A Review of the Shoreham Nuclear Power Station Probabilistic Risk Assessment

Internal Events and Core Damage Frequency

Brookhaven National Laboratory

Prepared for
U.S. Nuclear Regulatory
Commission

Table 5A.1 Functional Level Event Tree for the Probability of FW and PCS Unavailability Following a Turbine Trip. Short Term and Long Term Recovery Probabilities. Case of No SORVs. (Sheet 2 of 3)

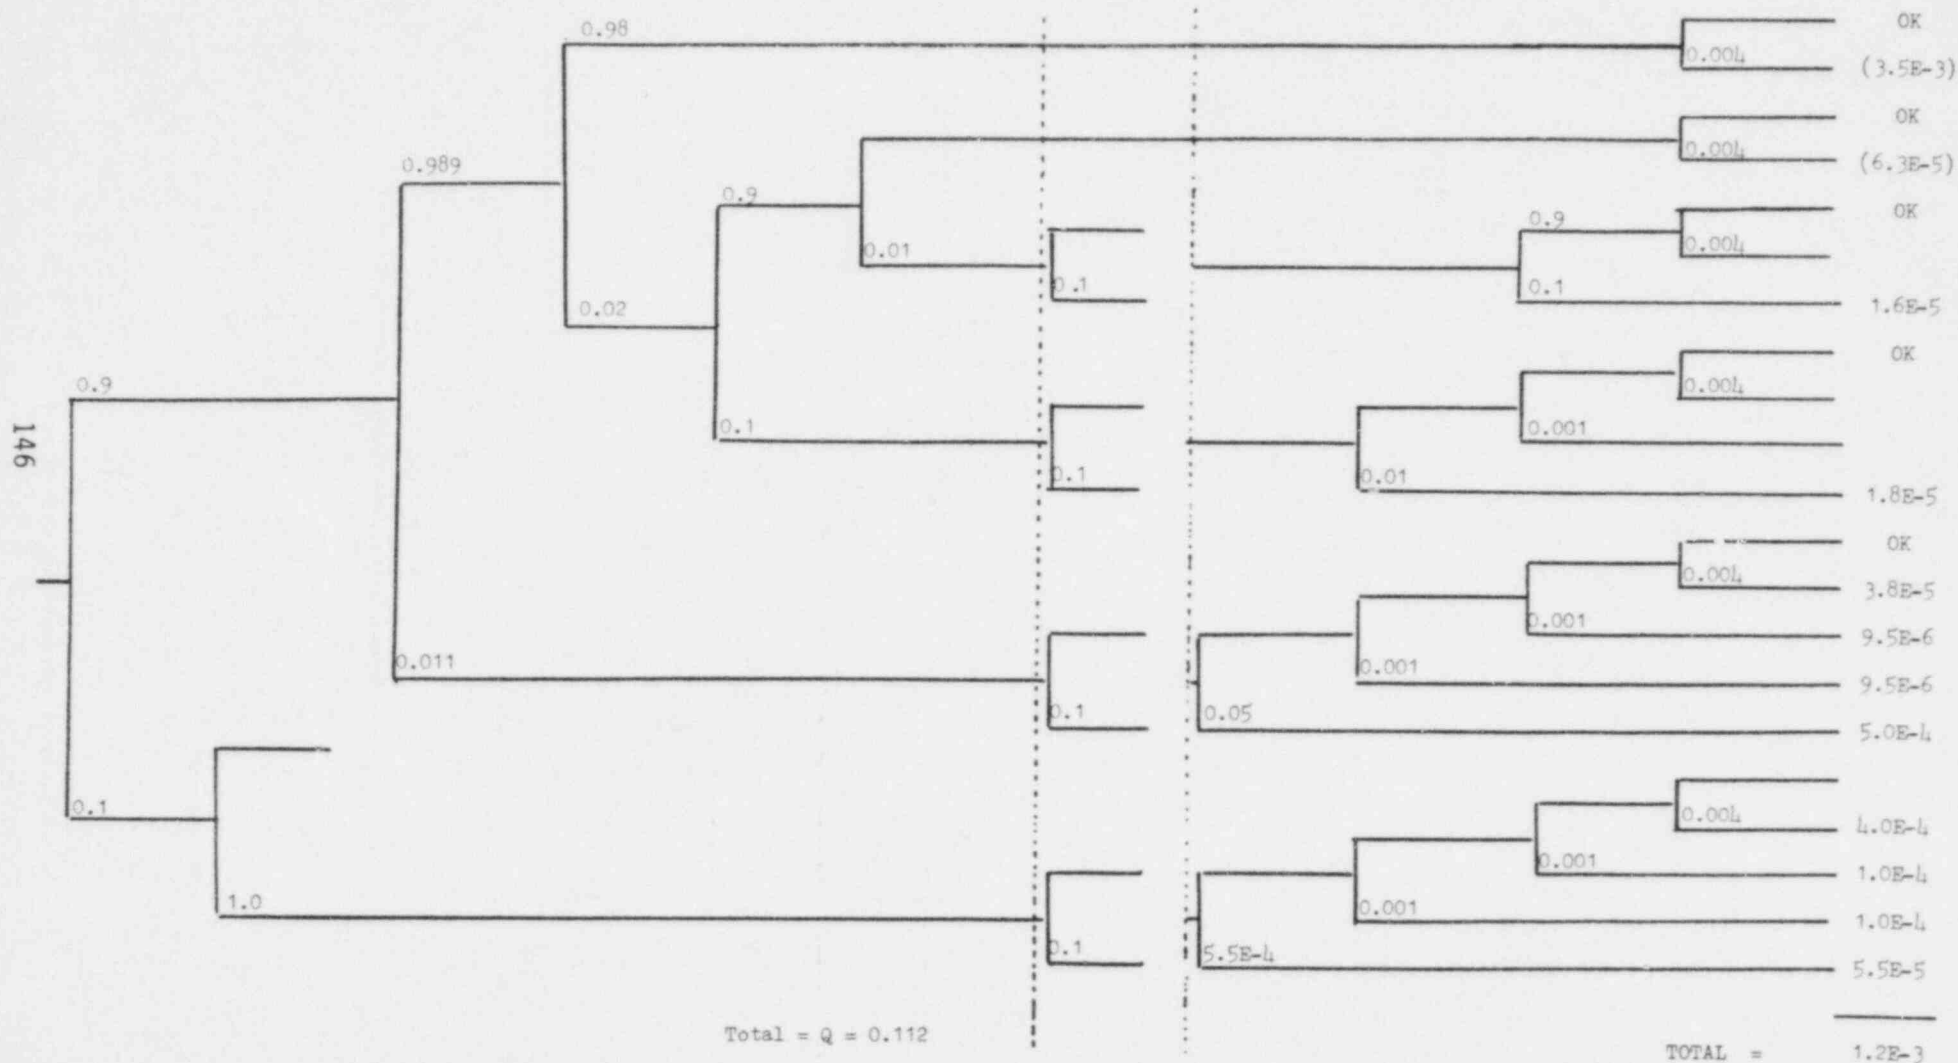
TOTAL = 1.05E-3
 $W'' = 1.05E-3 / 0.082$
 $= 0.013$

Figure 5D.1 Event Tree Diagram of Accident Sequences Following a Turbine Trip Initiator From High Power

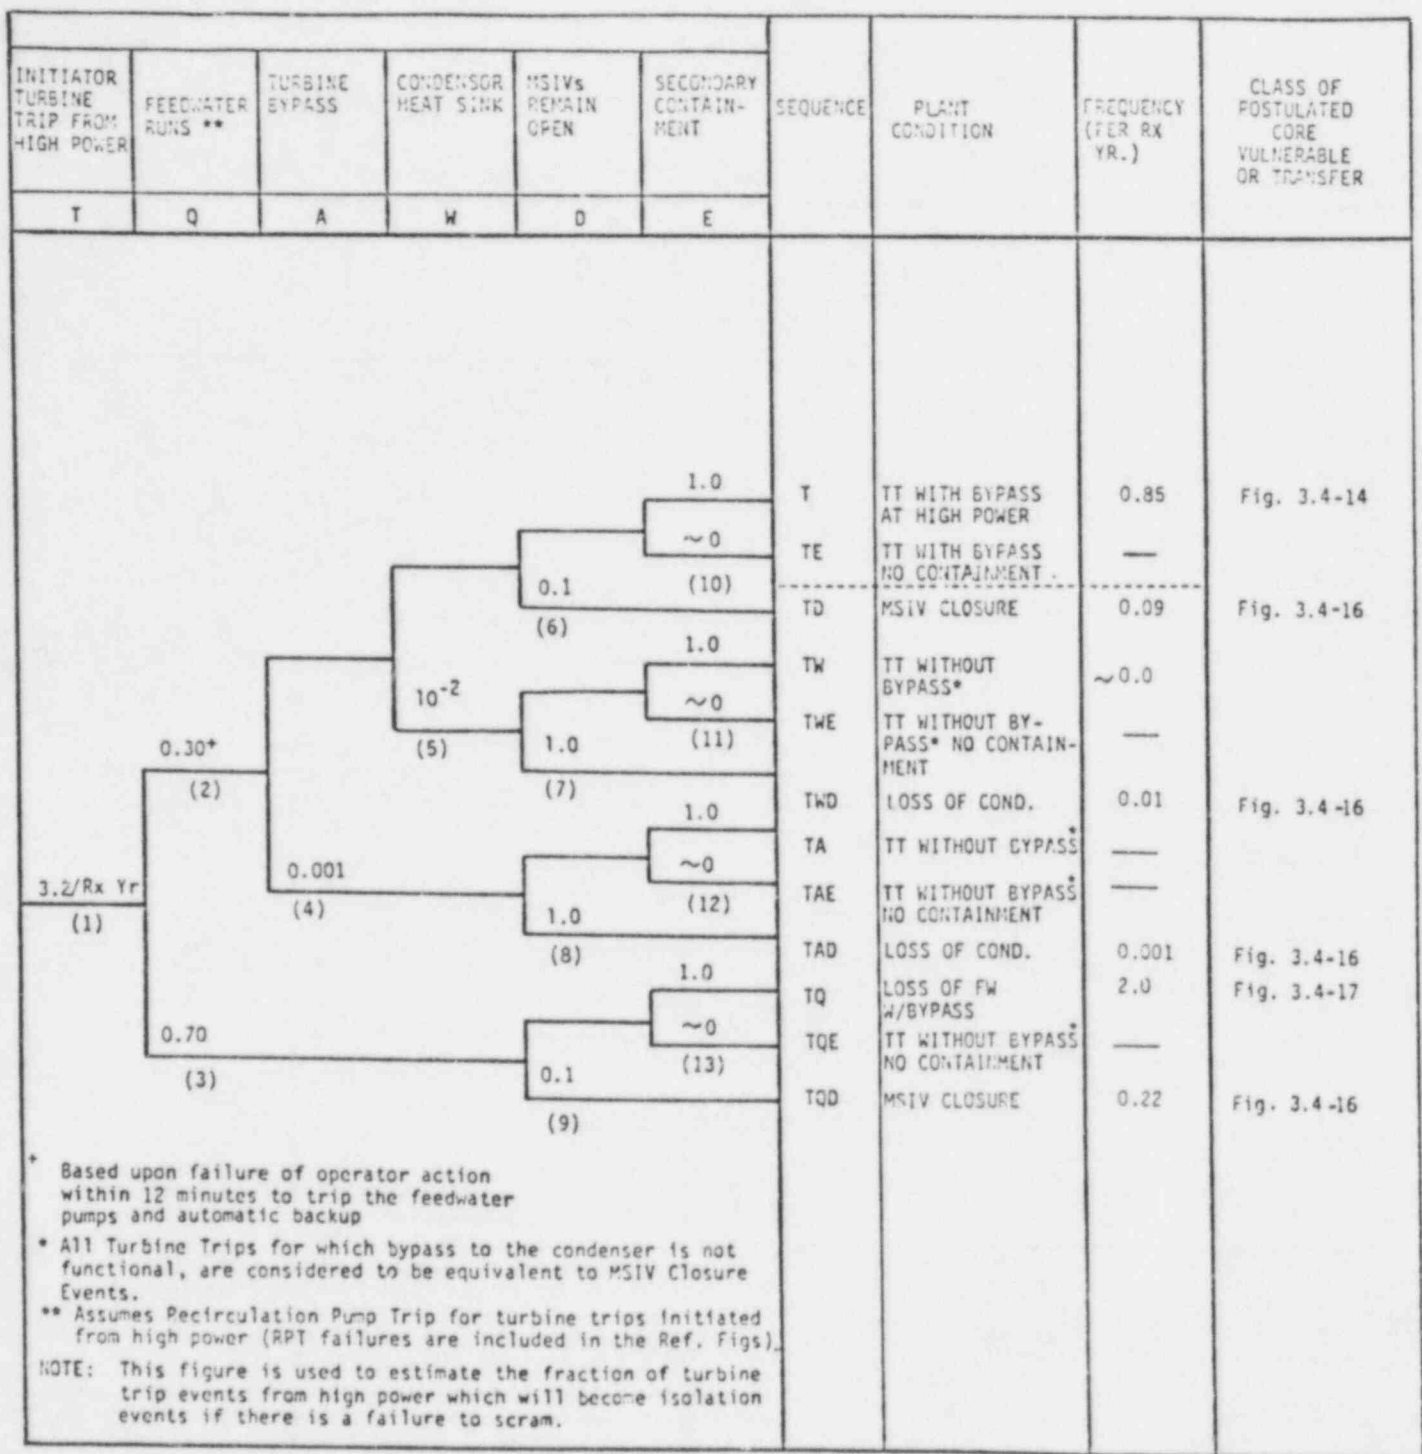
BNL's review of the SNPS turbine trip initiator event tree (Figure 5D.1) indicates that the function "feedwater runs" consists of feedwater runback action by the operator in 12 minutes, so as to preserve an orderly shutdown with low suppression pool temperatures. It is considered to have a high likelihood of failure in the SNPS-PRA. Failure of this function leads to either a loss of feedwater or a MSIV closure. However, this appears to contradict the definition of plant condition given for each sequence. For instance, the sequence T is characterized by the success of feedwater runback, turbine bypass, condenser heat sink, and MSIV open. But, if feedwater runback is successful, then the T sequence should behave more like a loss of feedwater than like turbine trip with bypass available. A similar example can be noted in the TQ sequence, where failure to runback, implying that feedwater is available, results in the loss of feedwater events. One possible explanation is that the upper branch of the feedwater run function should be interpreted as no feedwater runback. The SNPS-PRA states that a 0.4 operator error probability is assumed for failure to manually runback feedwater and a 0.75 failure probability is used for the automatic backup feedwater trip on Level 8.

As noted in the qualitative review of the SNPS turbine trip initiator event tree, BNL made minimum changes to this tree. The unavailability, 0.7, used by the SNPS-PRA on the feedwater runback function was found to be high. BNL thought that, given the onset of a turbine trip, regardless of whether it is an ATWS event or not, some portion of this event will result in either a MSIV closure or a loss of feedwater or loss of condenser, and developed a revised turbine trip initiator event tree accordingly (Figure 5D.8). The basic structure of this tree is similar to that in the SNPS-PRA. It has a total of four functions: feedwater trip due to high level, turbine bypass, condenser heat sink, and MSIVs remain open. Consistent with that used in the transient event analysis, a 10% probability is assumed for feedwater loss given a turbine trip initiator. In order to further distinguish loss of feedwater events from MSIV closure, a 20% probability is used for failure of the MSIVs to remain open. Loss of turbine bypass or condenser heat sink results in MSIV closure and loss of condenser events, respectively. Given the availability of the feedwater, the bypass and the condenser, the probability that the MSIVs will not remain open is assumed to be 0.02. The end states of this initiator event tree can be clarified into four groups: turbine trip, MSIV closure, loss of condenser, and loss of feedwater. Each of these is transferred to the respective ATWS functional event tree.

Figure 5D.8 Event Tree Diagram of Accident Sequences Following a Turbine Trip (BNL Review).

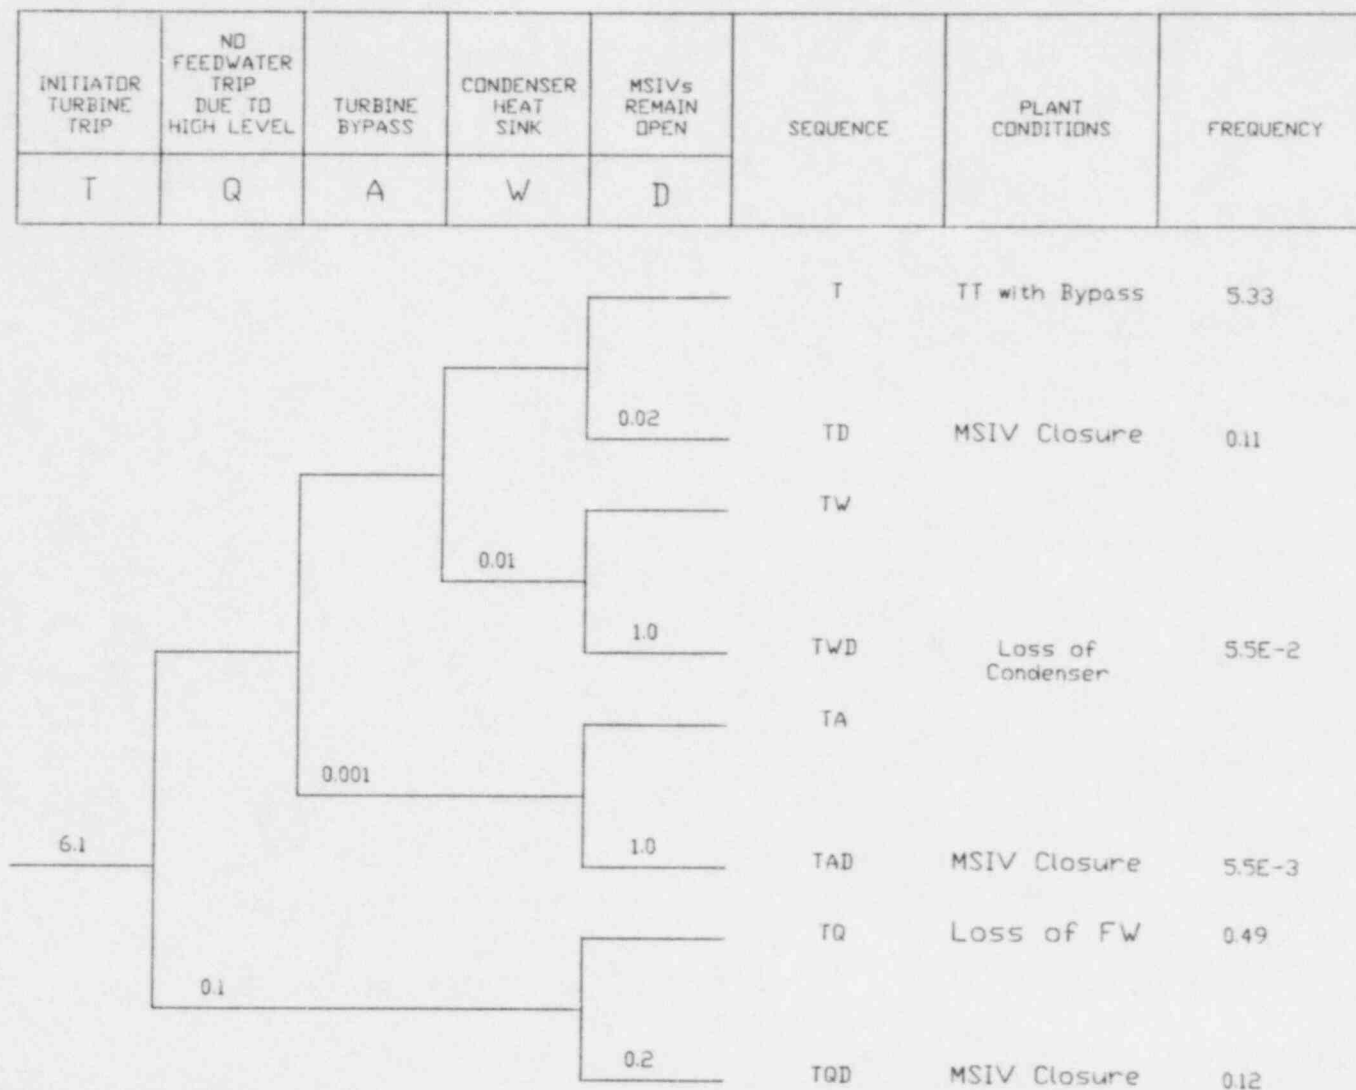
BNL analyzed the sequences following turbine trip and prepared an event tree similar to Figure 4.1 which is shown in Appendix 5D Figure 5D.8. The main difference in the BNL event tree is that BNL considered it more appropriate to treat the feedwater runback on the functional event trees for ATWS. The feedwater runback is one part of a set of procedural actions which the operator has to follow promptly. These actions also include manual actuation of the SLC system, reducing level and maintaining it above TAF, and ADS inhibit. In BNL's judgement, these actions are partially dependent.

The differences in the quantification of Figures 4.1 and 5D.8 result from the use BNL made of the turbine trip transient functional level event tree (Table 5A.1). The same values are used in ATWS Figure 5D.8 as in Table 5A.1 for the transient with successful scram.

Figure 5E.2 Fault Tree for Operator Error Causes Failure of Alternate Reference Leg (Sheet 1 of 2)

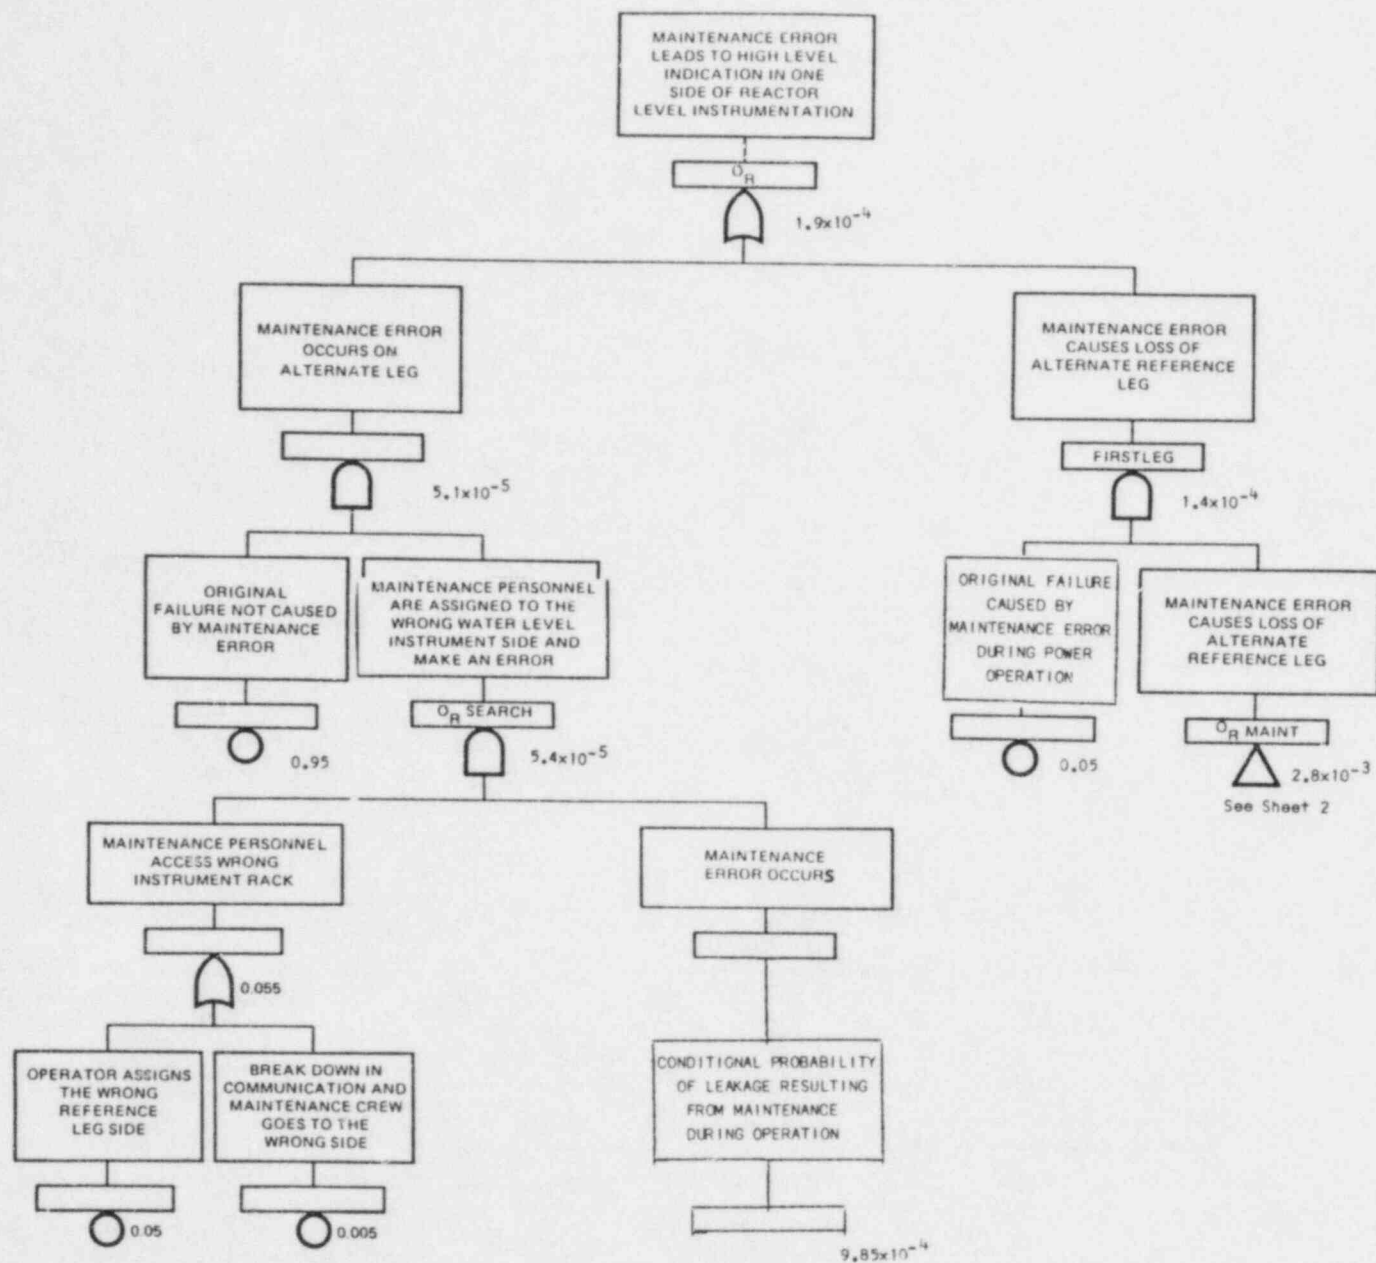
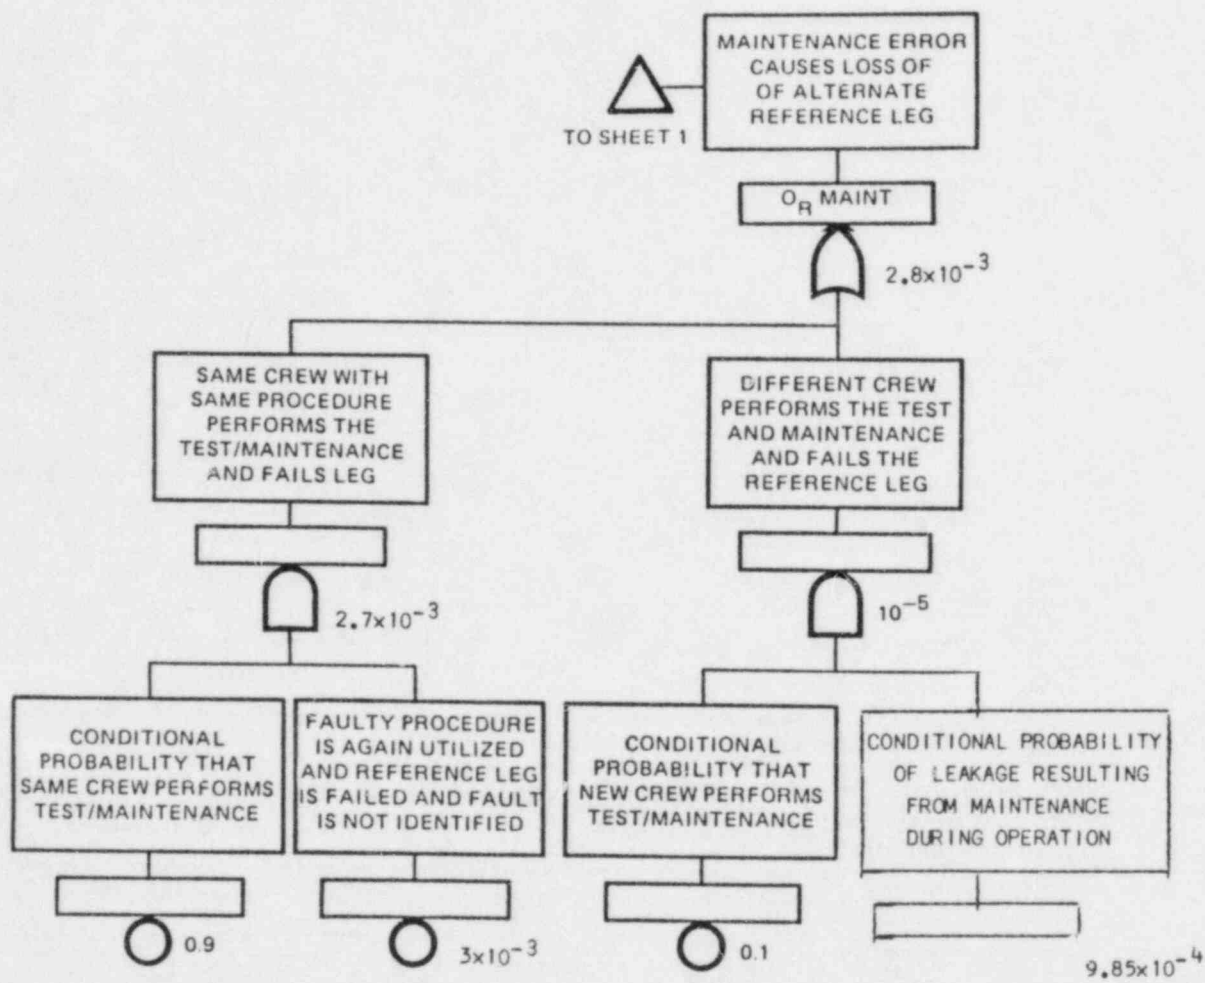
This is shown in the BNL event tree (Table 5E.2 Sheet 4). The frequency used in the BNL assessment is based on the revised functional fault tree (Figure 5E.2). This tree is based on the available LER data given in the PRA which includes two events of reference leg failure during maintenance when the reactor was at power operations. Appendix B of the SNPS study of water level instrumentation² evaluates the value for the "error rate for maintenance errors during power operation" on the basis of two LER events; the result is 0.000985 event/maintenance. This value is assumed by BNL to account for recovery, because reported LERs are generally events which have resulted in failure and were not immediately recovered.

Using the value derived above, the SNPS-PRA functional fault tree (Figure D.2 of Ref. 2) was revised by BNL as shown in Figure 5E.2. In addition, the value for operator error utilizing repeatedly faulty procedures was judged low and was increased by BNL by a factor of 3 above the SNPS-PRA value. The result $O_R = 1.9 \times 10^{-4}$, which is sevenfold higher than that calculated by the SNPS-PRA, is used in the BNL event tree (Table 5E.2 Sheet 4). The other details of this event tree are similar to those in the SNPS-PRA. This sequence ($TRORQX = 2 \times 10^{-6}$ in Class I) became a significant contributor in the BNL reassessment, in contrast to the SNPS-PRA, because of the change described above. This sequence is associated with the use of two reference legs in the SNPS design.
